COVER DOCUMENT

System Pillar / EULYNX

Baseline Set 4 Release 3

Version: 3.4
Date: 30-06-2025

Eu.Gen-SMI.50

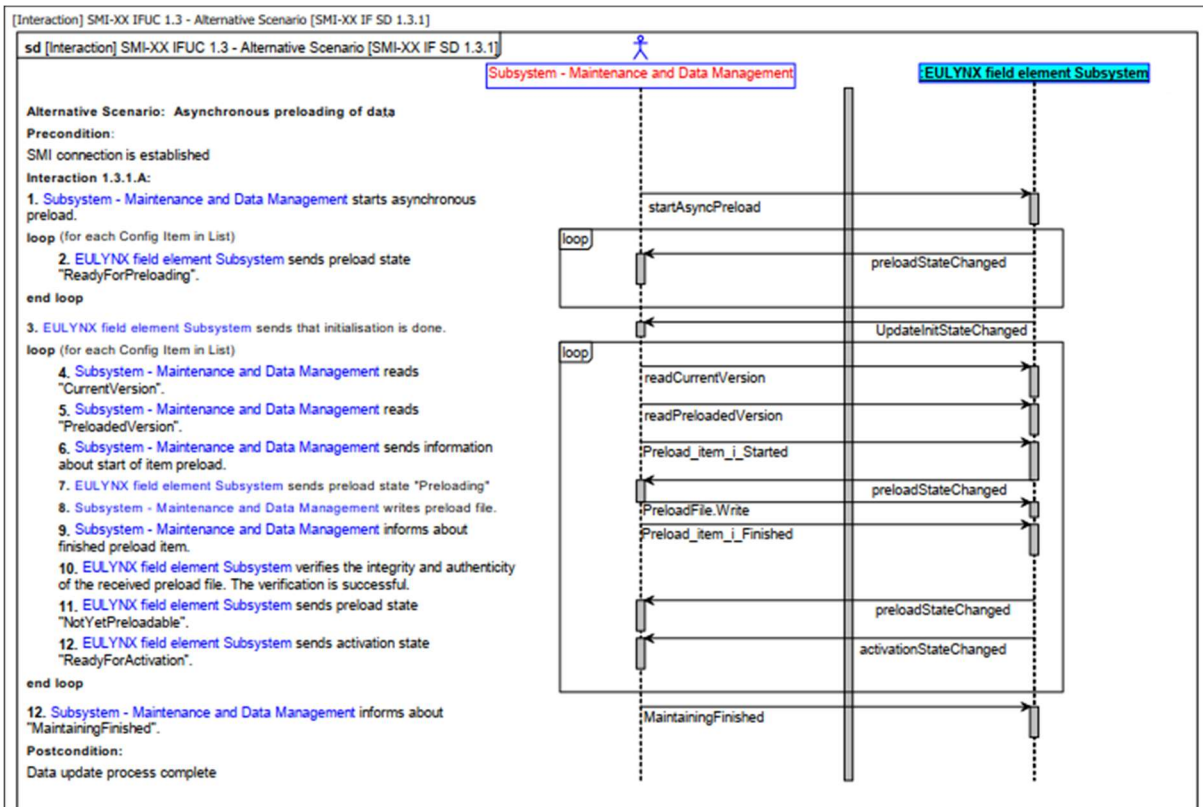
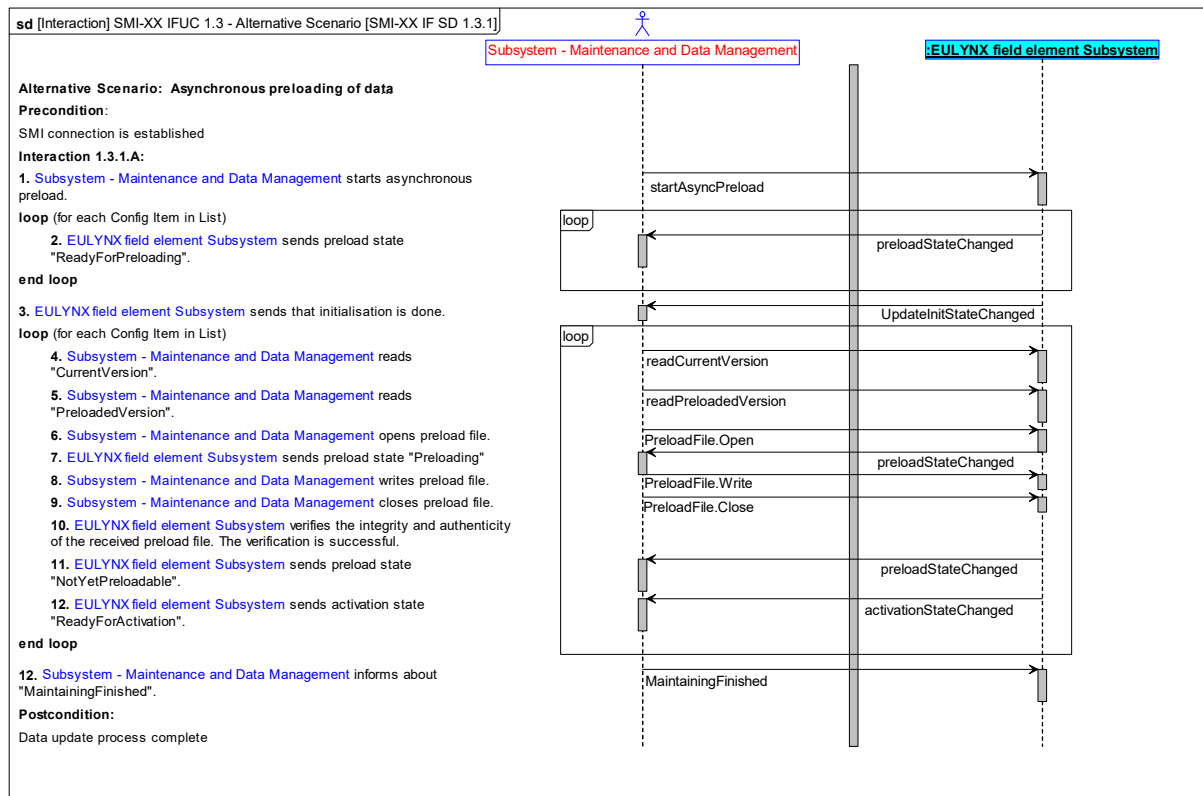
2. In several SDs, the arrow Preload_item_i_Finished must be replaced with PreloadFile.Close. With description:
Subsystem - Maintenance and Data Management
~~informs about finished~~
closes preload file

New STM F_SMI_EfeS

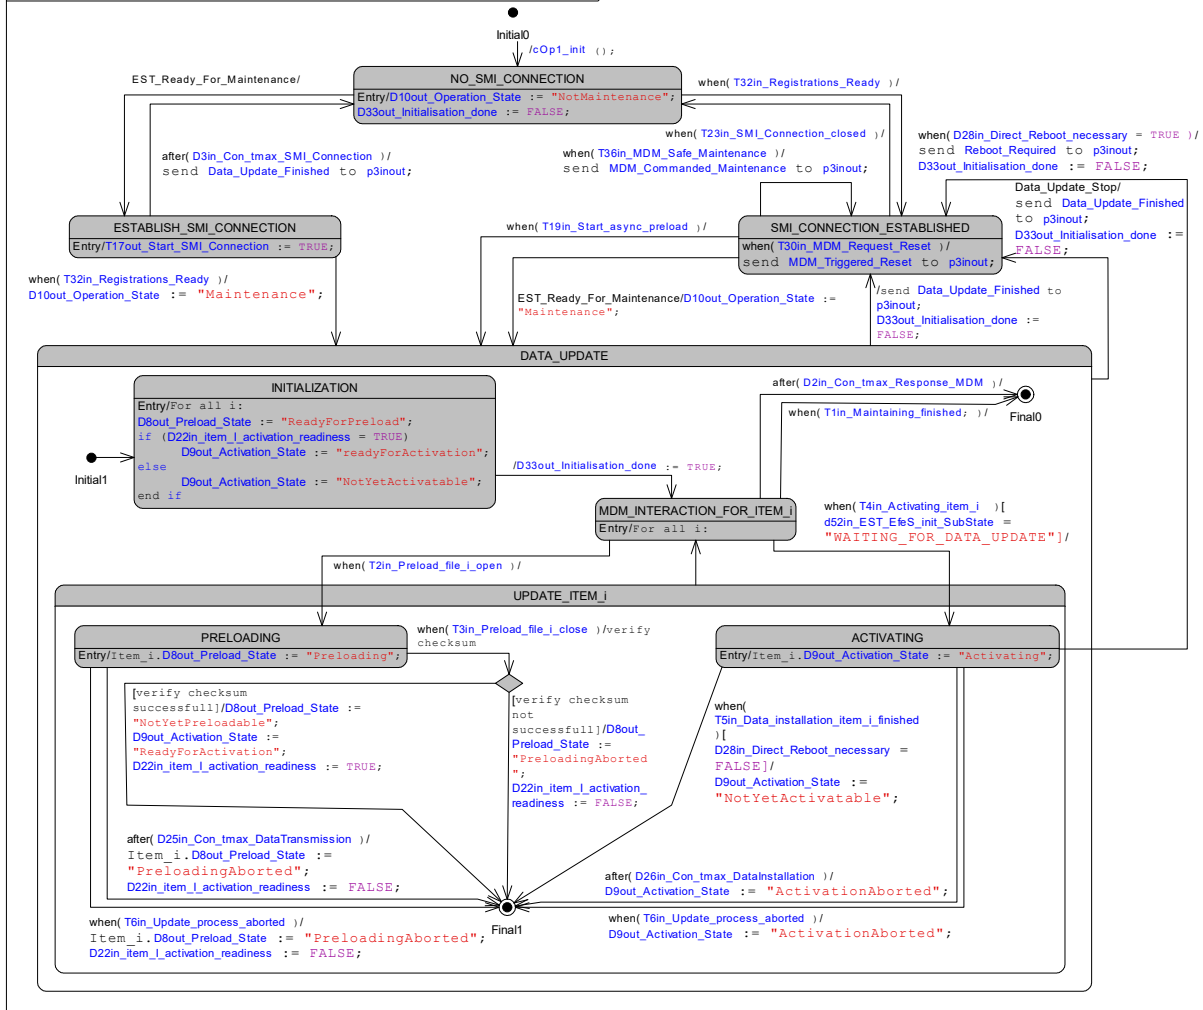
3. In the STM, two ports and two FlowProperties must be renamed and description aligned.
T2in_Preload_item_i_started > T2in_Preload_file_i_open
T3in_Preload_item_i_finished > T3in_Preload_file_i_close
Preload_item_i_started > PreloadFile.Open
Preload_item_i_finished > PreloadFile.Close
[Eu.Doc.76]

T2in_Preload_item_i_started > T2in_Preload_file_i_open

T3in_Preload_item_i_finished > T3in_Preload_file_i_close

Preload_item_i_started > PreloadFile.Open

Preload_item_i_finished > PreloadFile.Close

Eu.SMI.233

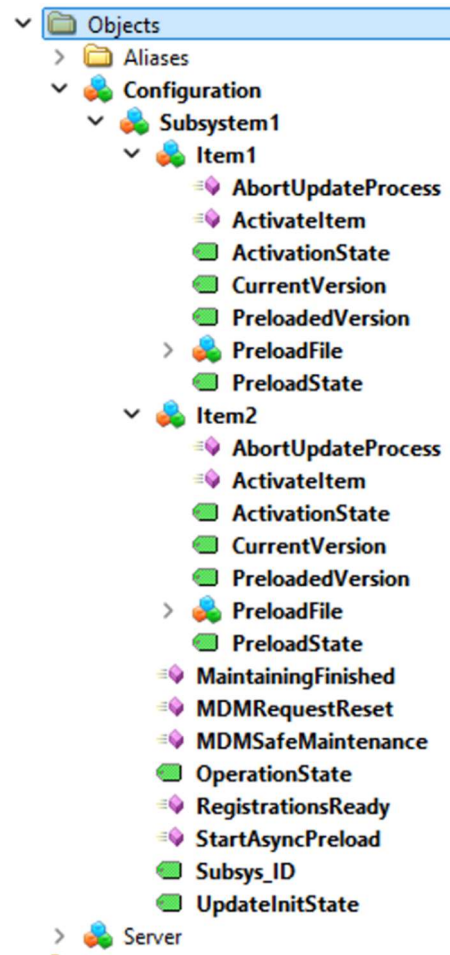
4. Delete PreloadItemFinished and PreloadItemStarted from the information model figure and tables.
5. Improve and extend description of PreloadFile to describe the interactions PreloadFile.Open, PreloadFile.Write and PreloadFile.Close.

KKI raised that there is no need to have an explicit attribute 'Version' on the top level of the OPC UA model for SMI. Such an attribute was added in BL4R3 with ticket EUAR-641.

Remove again the attribute 'Version' from the OPC UA model of SMI.
In figure in Eu.SMI.233 and in table in Eu.SMI.244.
